Subject: 69 MW Lawi Hydropower Project, District Chitral, Khyber Pakhtunkhwa, Application for Generation License

LAWI HYDROPOWER PROJECT
69 MW

VOLUME-I EXECUTIVE SUMMARY

DWG: No. S - 002

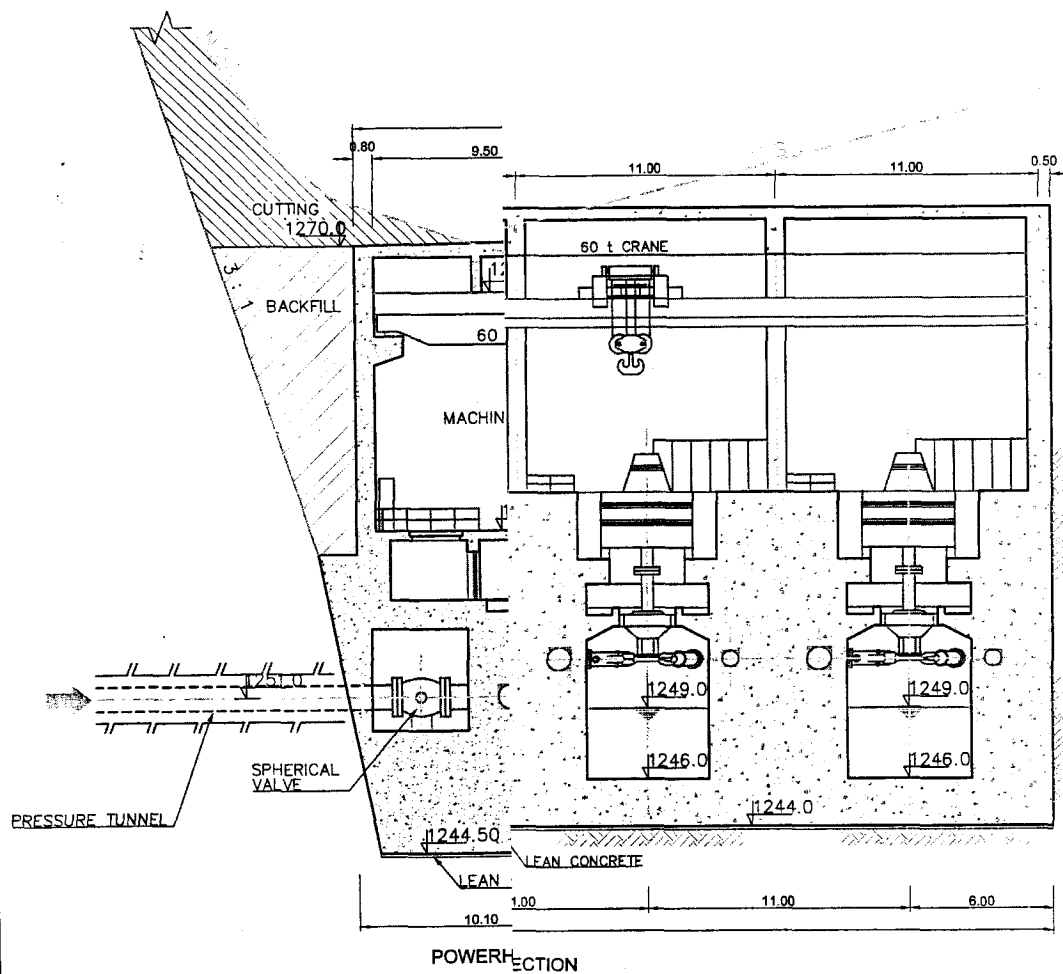
3. Cut slopes in rock and alluvium shown in DWG 6-11 and DWG 6-45 do not tally with each other.
4. Transverse sections in DWGs S-002 and 6-47 show NSL as 1670 masl near left abutment. Longitudinal sections in DWG S-002 and Section B-B in DWG 6-47 have been drawn at the centre of the weir where NSL is 1661. If a similar longitudinal section is drawn close to the left abutment, it will show 14 m deep cut all along the section indicating requirement of proper cut slope during construction. Therefore, a few more such sections are required to be developed using new detailed topo survey to estimate the quantities of cut and backfill material.

2. On page 9-7 the height of pressure shaft is $238+100=338$ m while on the drawing it is shown as 332.5 m.
3. On page 9-9 length of tailrace channel is 130 m while on above mentioned drawing it is 120 m.
4. On page 9-8 length of powerhouse is 56 m while in above mentioned drawing it is 40 m.
5. On drawing 6-11 gate size of flushing gate is 4.0 m x 3.0 m while on drawing 6-45 it is 2.5 x 2.0 m.
6. Figure S002: Top of upstream and downstream stone apron should be at NSL
